**Final Independent Engineering Expert Opinion  
Report for the U.S. Office of Special Counsel (OSC)  
on Hydraulic Pumping Equipment Related to  
Three Major Flood Protection Structures in New  
Orleans**

*Covering Contract 20080028 OSC-MGT-045-2008 - Scope C-3 (Only)*

*20 May 2009*

Figure 5 - Cross-section (across test piping) of Percentage of Maximum Observed Flow Measurements from Flow Test 4-7 Data

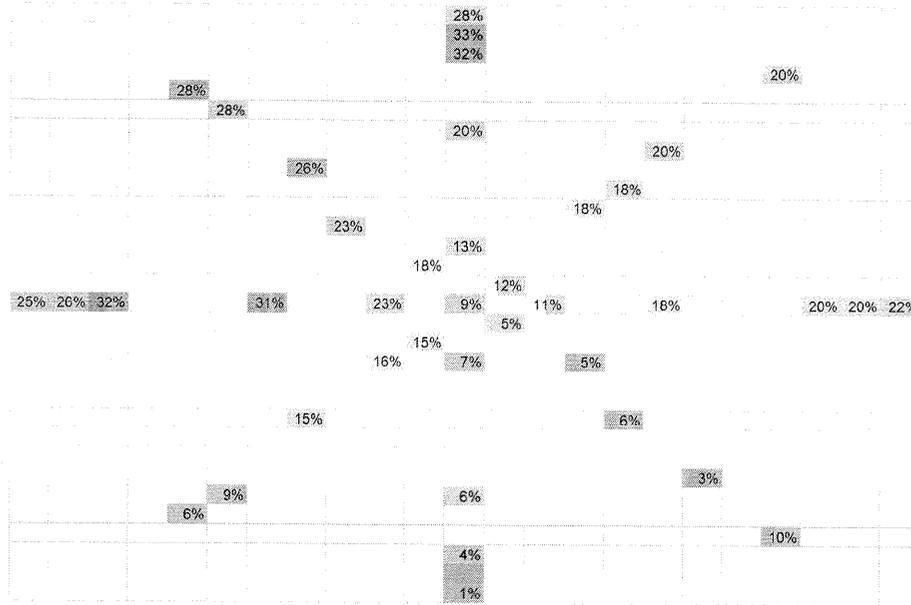
The information shown in Figure 5 portrays a 38% flow differential across the measurement cross section, and this type of flow differential can be caused by flow imbalances and cavitation and most certainly leads to inaccurate flow representations, especially when all of the measurement cannot be taken at the same time.

Figure 6 - Interpolated Representation from Flow Test 4-7

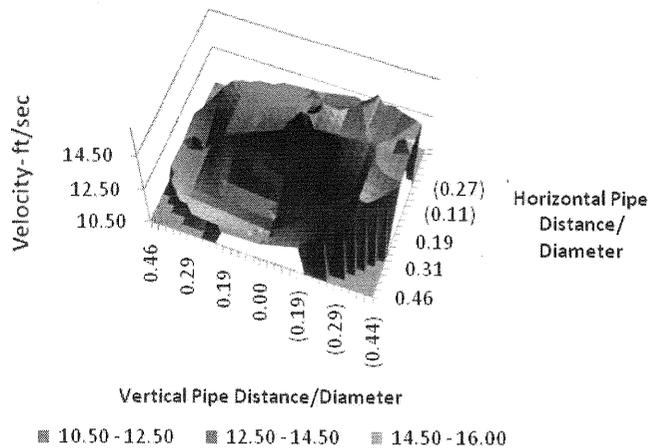
The bearings in the water pumps should be inspected for damage because of these turbulent observations, as well as inspecting the pump impeller for cavitation damage.

Figure 7 - Combined L10 Graphs from Rineer

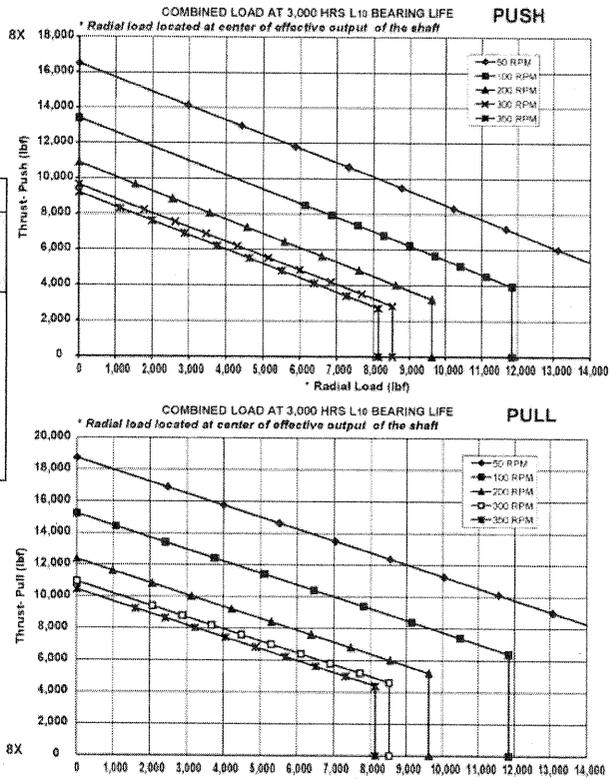
2. DRAINAGE PUMP (Page 7 of 32)		
Section	Solicitation and MWI Contract Requirement	Requirement Met?
2.2.3	The shaft bearing shall be sealed, self-lubricating by low pressure hydraulic oil designed for bearing life of 50,000 hours use.	"NO" - Bearing life from Rineer was not designed for more than 3,000 L10 hours of use.

While one could argue the bearings installed by MWI eliminated all stresses on the Rineer hydraulic motor, this would be unlikely. MWI has guaranteed 50,000 L10 hours of use for a part from another vendor without extensive testing to verify the 50,000 hours for L10.

Figure 8 - HP & Thrust Limits for Rineer Motor

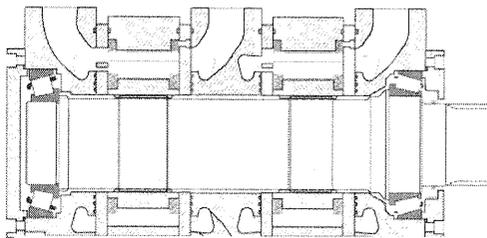
MWI did not provide any additional information that would convincingly show that the Rineer Motor used in the MWI hydraulic pump was fully capable of handling 735HP, as well as ensuring the combined axial and radial thrust does not exceed

Figure 9 - Hydraulic Oil Temperature Sensor in Wrong Location

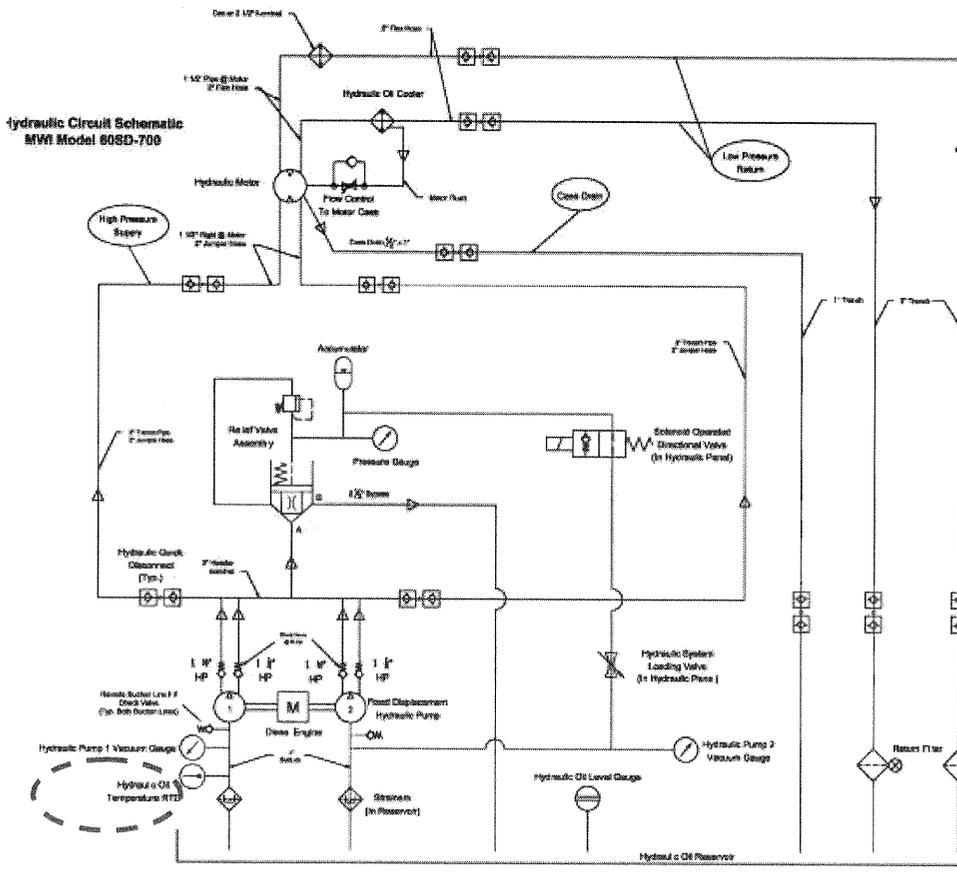
The temperature sensor for the hydraulic oil temperature was located upstream of the discharge of the Denison hydraulic motor.

Discharge from the Denison hydraulic oil pump will always be hotter than the temperature on the suction side of the pump. Potentially the oil temperature on the discharge side of the Denison hydraulic oil pump could exceed the maximum allowable temperature for the Rineer seals and fail before an unacceptably high temperature is ever sensed by the hydraulic oil temperature detector (RTD)

Figure 10 - Poorly Coated Part

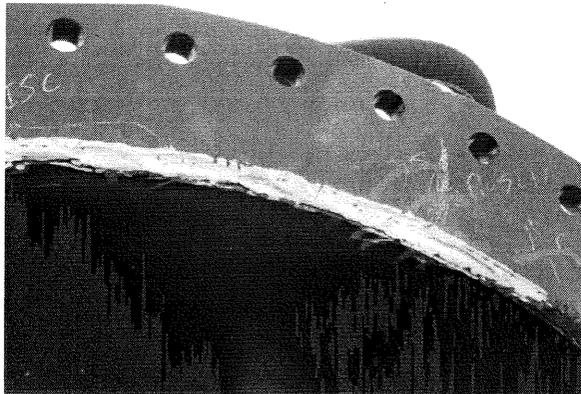
2. DRAINAGE PUMP (Page 7 of 32)		
Section	Solicitation and MWI Contract Requirement	Requirement Met?
2.2.5	The complete pump assembly shall be sand blasted to near white and painted inside and out with black bitumastic enamel equal to Zophar triple A or with Porter Taset epoxy or equal.	"NO" - Some pump assembly parts were not sand blasted and painted as required.

There are numerous pictures of exposed and uncoated parts of the pump system. Requirement 2.2.5 was not met.

Figure 12 - Torque vs Engine RPM for Caterpillar 3412 Diesel Engine

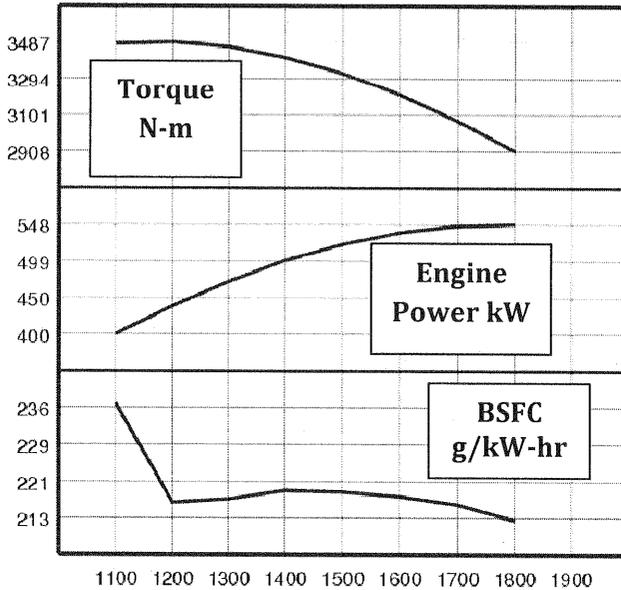
**(Observation 2-D)** Torque on a diesel engine is higher at low RPM. Figure 12 shows that the torque on the Caterpillar 3412 Diesel Engine with 735 bhp delivers about 3476 Newton-meters (N-m) at 1100 rpm or 2564 ft-lbf.

Figure 13 - Comparison of Caterpillar 3412 Engines Torques with the Maximum Allowable Durst 2DP10 2 Pad Pump Drive Torque

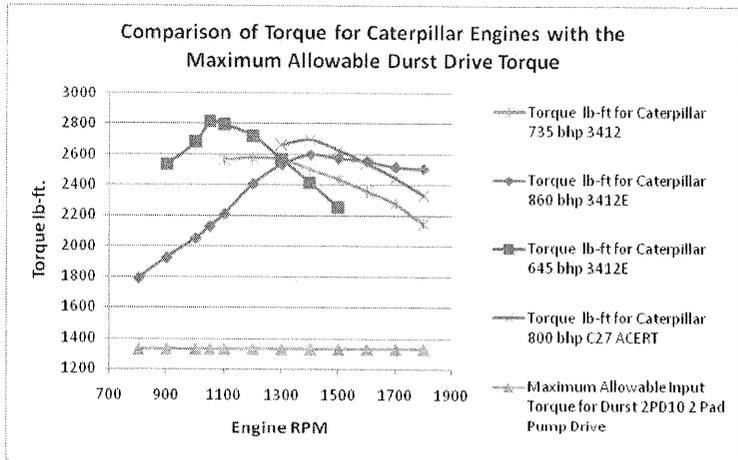
No matter which equivalent Caterpillar 3412 (or follow-on C27 ACERT) engine was selected, the engine torque would have exceeded the maximum allowable torque and the maximum allowable horse power for any available Durst clutch (see torque values as shown in Figure 13).

Therefore, it is clear that MWI did not provide the required clutch as represented in its proposal and MWI did not meet this clearly stated requirement in the USACE solicitation.

Figure 16 - Copy of Figure 2. Schematic of Test Flume from Factory Tests of MWI Pumps

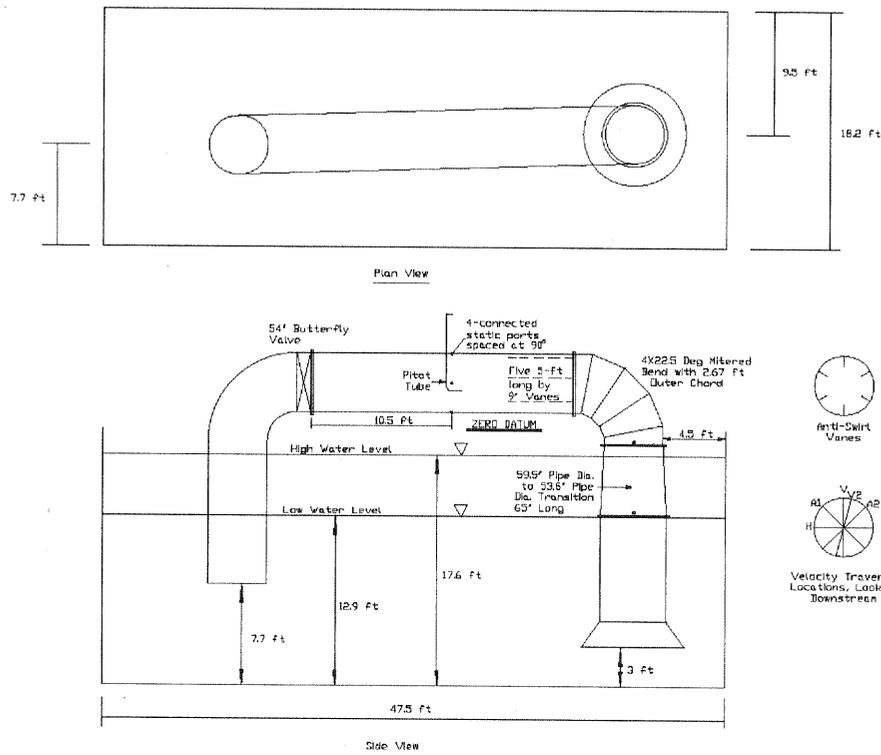
The side view and top view of Figure 16 shown on page 58 of this document, clearly shows that the first condition, mentioned above, "a. Straight conduit upstream and downstream of the measurement location of 20 and 5 pipe diameters, respectively." was not met for the testing. The nominal pipe diameter described at the location of the Pitot tube was 53.6 inches (4.5 ft.), which would mean that the Pitot tube measuring point was just only slightly more than two (2) pipe diameters instead of the required upstream 20 pipe diameters.

The proximity of the 90° elbows shown in Figure 16, make it very difficult to conform to the second requirement mentioned above “b. Velocity distribution shall, as nearly as possible, be that of fully developed flow in a straight conduit, of uniform section.”

The entire section of pipe where the measurements were made was far less than the required number of pipe diameters upstream and therefore did not meet the condition stated above of “d. If flow conditioners are required, they should be placed 10 pipe diameters upstream.” This deficiency is obvious and apparent when viewing figure 4 showing the flow straighteners in the short (less than 5 pipe diameters away) section of pipe.

Figure 17 - Cross-section (across test piping) of Percentage of Maximum Observed Flow Measurements from Flow Test 4-7 Data

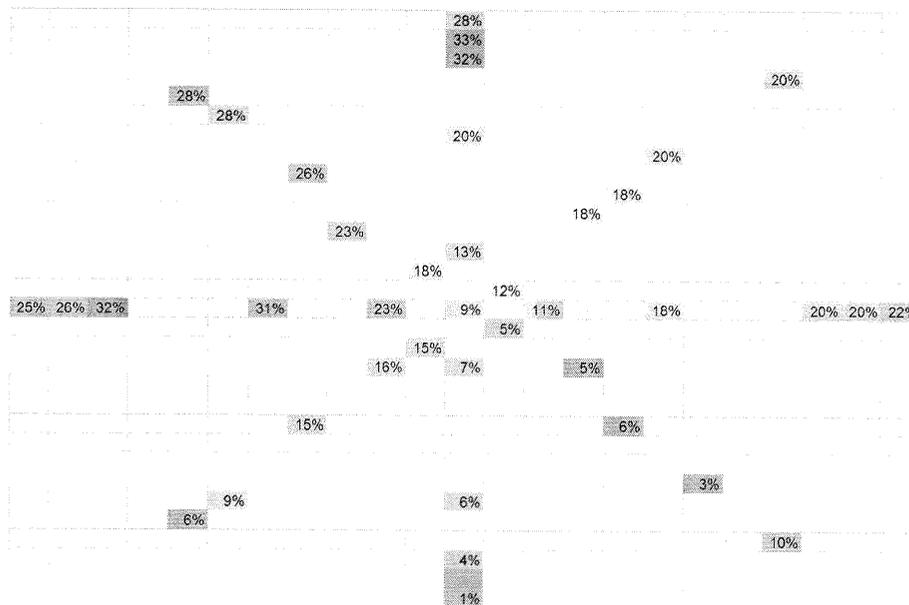
The information shown in Figure 17 documents nearly a 40% flow differential across the measurement cross section, and this type of flow differential can be caused by flow imbalances and cavitation and most certainly leads to inaccurate flow representations, especially when all of the measurement cannot be taken at the same time.

Figure 19

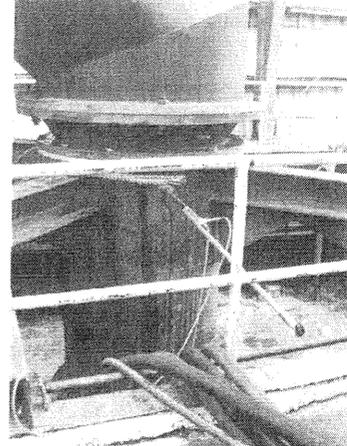
"Pic. No. 15 - Unmarked pitot tube in the Discharge Pipe on 4/12/2006" is shown in Figure 19 clearly shows that MWI was attempting to conduct some sort of flow measurement test that was unacceptable by HIS standards, unless there was a hidden section of vertical piping between the test point and the pump that was at least 22-88 feet long (or the tank had to be more than 22-88 feet deep.

However, the suspended unit shown in "Pic. No. 7-Original testing apparatus-note size of testing tank (outline by yellow handrail) in relation..." Clearly shows that the distance between the outlet of the pump and the point where the measurement was being made in Figure 19 of this document was no more than three pipe diameters when it should have been 5 to 20 diameters. Therefore, any flow measurements did not conform to the requirements of Gen. engineering principles for using pitot tubes and most certainly did not conform to ASME document PTC 18-2002 or ASME PTC 18-1992.

Figure 20

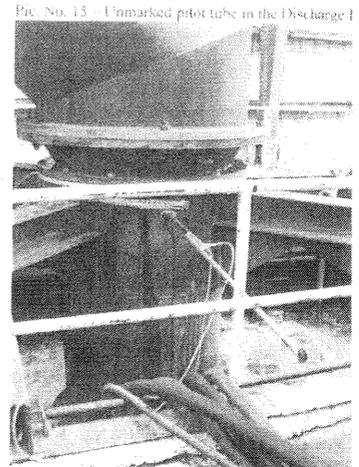
"Pic. No. 15 - Unmarked pitot tube in the Discharge Pipe on 4/12/2006" is shown in Figure 19 clearly shows that MWI was attempting to conduct some sort of flow measurement test that was unacceptable by HIS standards, unless there was a hidden section of vertical piping between the test point and the pump that was at least 22-88 feet long (or the tank had to be more than 22-88 feet deep.

However, the suspended unit shown in "Pic. No. 7-Original testing apparatus-note size of testing tank (outline by yellow handrail) in relation..." Clearly shows that the distance between the outlet of the pump and the point where the measurement was being made in Figure 19 of this document was no more than three pipe diameters when it should have been 5 to 20 diameters. Therefore, any flow measurements did not conform to the requirements of Gen. engineering principles for using pitot tubes and most certainly did not conform to ASME document PTC 18-2002 or ASME PTC 18-1992.

Figure 22 - Copy of Figure 2. Schematic of Test Flume from Factory Tests of MWI Pumps

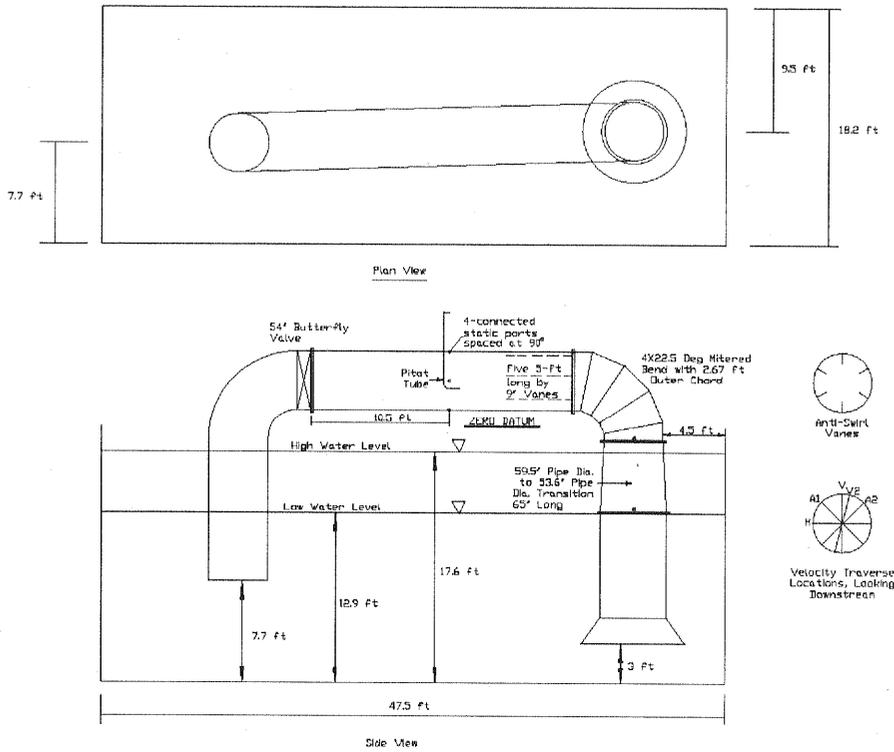
The side view and top view of Figure 16 shown on page 58 of this document, clearly shows that the first condition, mentioned above, “a. Straight conduit upstream and downstream of the measurement location of 20 and 5 pipe diameters, respectively.” was not met for the testing. The nominal pipe diameter described at the location of the Pitot tube was 53.6 inches (4.5 ft.), which would mean that the Pitot tube measuring point was just only slightly more than two (2) pipe diameters instead of the required upstream 20 pipe diameters.

The proximity of the 90° elbows shown in Figure 16, make it very difficult to conform to the second requirement mentioned above “b. Velocity distribution shall, as nearly as possible, be that of fully developed flow in a straight conduit, of uniform section.”

The entire section of pipe where the measurements were made was far less than the required number of pipe diameters upstream and therefore did not meet the condition stated above of “d. If flow conditioners are required, they should be placed 10 pipe diameters upstream.” This deficiency is obvious and apparent when viewing figure 4 showing the flow straighteners in the short (less than 5 pipe diameters away) section of pipe.

Figure 24 - Rusty Corroding Untreated Pipes and Components

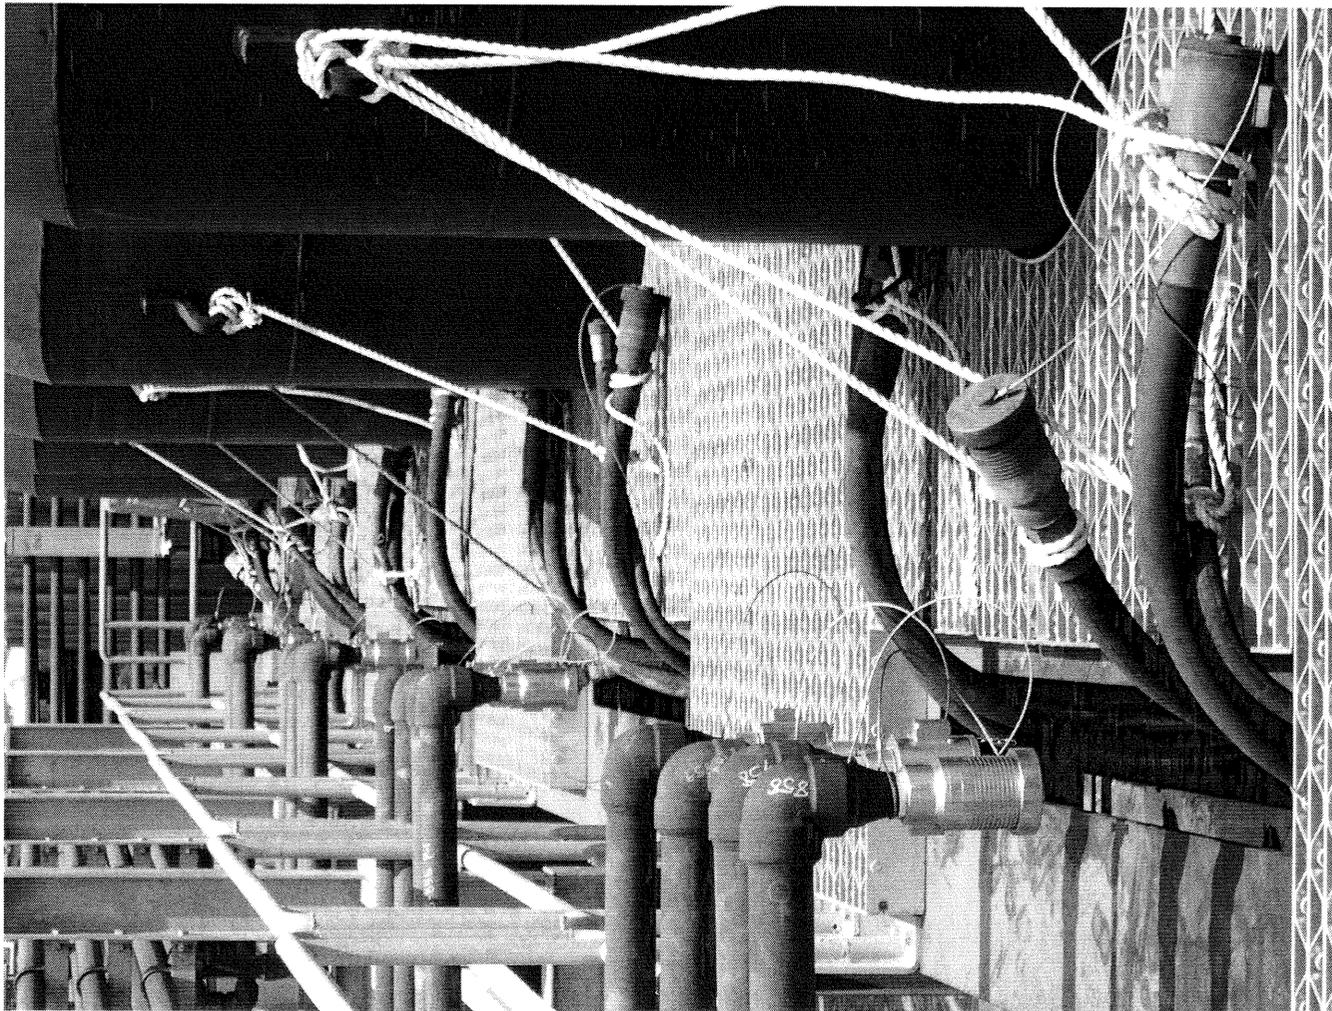
*Also related to this issue: a reoccurring problem was documented in late June 2006 - thermal expansion of the hydraulic oil in the piping causing the oil to come up and out the fill cap in significant quantities (gallons). ..."*

Figure 25 - Note Position of Oil Cooler

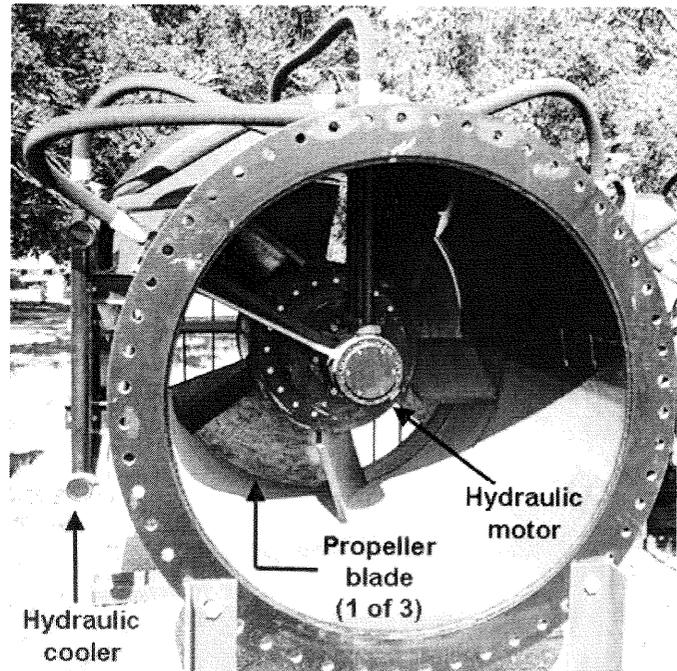
**(Observation 4-E)** Note the position of the oil cooler in Figure 25. Without examining the detailed design the effectiveness of the hydraulic oil cooler is very poor. The hydraulic oil overheated or ran at very high temperatures (in excess of 200° F) during many of the factory tests. Picture No. 58 provided from the OSC shows an oil cooler with a relatively small surface area for the transmission of thermal energy from hot hydraulic oil to the surrounding water, and because the water around the outside of the water pump may not be moving very much, then the thermal gradient from the inside of the cooler to the outside of the cooler will diminish over time and consequently the effectiveness of the cooler will go down. If there is any turbulence around the water pump intake, the effectiveness of the hydraulic oil cooler will be even less. This is a very poor design and a very poor location for the hydraulic oil cooler. The hydraulic oil cooler would have been much more effective if the designer had put fins on the outside of each one of the pipes to increase the cross-sectional area on the outside of the pipes.
